**An Independent Review of the Financial Viability Assessment**

**Submitted in Support of Planning Application 16/05464**

**for the Extraction of Sand at Freeth Farm**

**By Dr Peter Alberry**

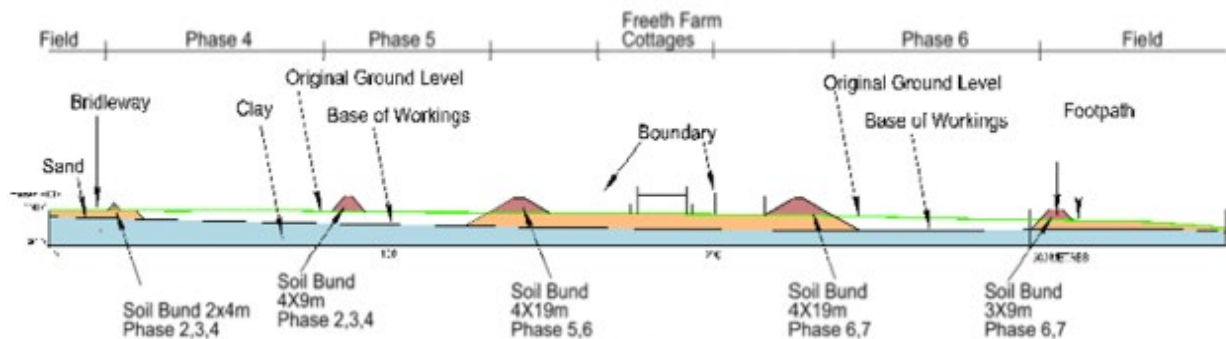
The sand tonnages were calculated by Brunel Surveys Limited using a 3D model to estimate the extracted volumes based on the bore hole depths and then estimated the amount of sand lost as a result of increasing the buffer zone from 10m to 35m (referred to below as a stand-off distance). The lost mineral production from the increase in buffer zone is shown in yellow in the diagram below, as taken from HQPL’s submission.

Note: The noise attenuation bund dimensions shown above are incorrect as they would actually be 4m high and 15m wide (as shown below) and not 3m high and 9m wide (as shown above). However, as the bunds are constructed using top soil, they do not affect the amount of sand available for extraction or the amount of lost sand production due to the increase in buffer zone from 10m to 35m as measured from the boundary of Freeth Farm Cottages to the edge of the workings.
